City of Phoenix
PLANNING AND DEVELOPMENT DEPARTMENT

Staff Report Z-110-24-8
December 2, 2024

South Mountain [Village Planning Committee](#) Meeting Date: December 10, 2024
[Planning Commission](#) Hearing Date: January 2, 2025
Request From: [S-1 BAOD](#) (Ranch or Farm Residence, Baseline Area Overlay District) (1.00 acres)
Request To: [P-1 BAOD](#) (Passenger Automobile Parking, Limited, Baseline Area Overlay District) (1.00 acres)
Proposal: Parking Lot
Location: Approximately 475 feet south of the southeast corner of 32nd Street and Southern Avenue
Owner: Patricia Christofolo, 32nd St Property, LLC
Applicant/Representative: Kay Shepard
Staff Recommendation: Approval, subject to stipulations

Conceptual Site Plan; Source: Greg Loper

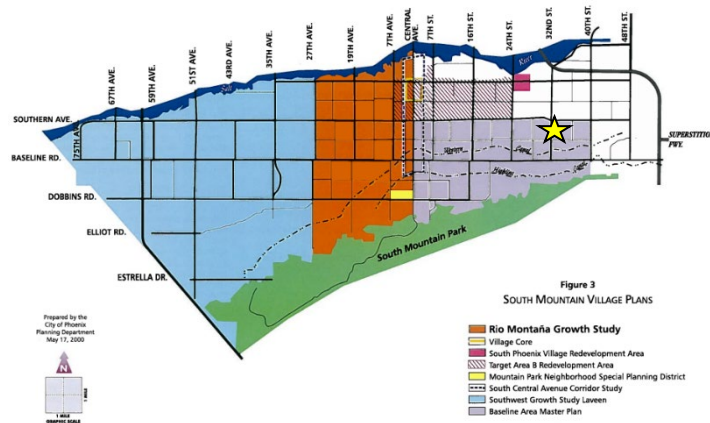
The P-1 zoning district does not include landscape standards. To address this, staff recommends stipulations to require landscape setbacks and planting standards consistent with the Mixed Use Agricultural (MUA) zoning district. To ensure compatibility with the surrounding area, the MUA General Plan Land Use Map designation, and the Baseline Area Master Plan, staff recommends Stipulation Nos. 1, 2, and 4 to require enhanced landscape setbacks and view fencing. Staff recommends Stipulation No. 3 to require pavement treatments that visually contrast with parking and drive aisles where pedestrian walkways cross a vehicular path. Staff recommends Stipulation No. 6 to require the surface parking spaces be

shaded and Stipulation No. 7 to require all walkways be shaded above minimum Zoning Ordinance standards.

1. A minimum 30-foot-wide, average 35-foot-wide landscape setback shall be provided along 32nd Street and planted to the MUA streetscape landscape standards as listed in Section 649.H.3 in the Phoenix Zoning Ordinance, as approved by the Planning and Development Department.

2. A minimum 10-foot-wide landscape setback shall be provided along the north, east, and south perimeter of the site and planted with minimum 2-inch caliper, large canopy, shade trees planted 20 feet on center, or in equivalent groupings, and shrubs, accents, and vegetative groundcovers evenly distributed throughout the landscape areas to achieve a minimum of 50% live coverage, as approved by the Planning and Development Department.

6. All uncovered surface parking lot areas shall be landscaped with minimum 2-inch caliper, single-trunk, large canopy, shade trees. Landscaping shall be

dispersed throughout the parking area and achieve 25% shade, as approved by Planning and Development Department.

7. All pedestrian pathways (including sidewalks) shall be shaded by a structure, landscaping, or a combination of the two to provide a minimum of 75% shade, as approved by the Planning and Development Department.
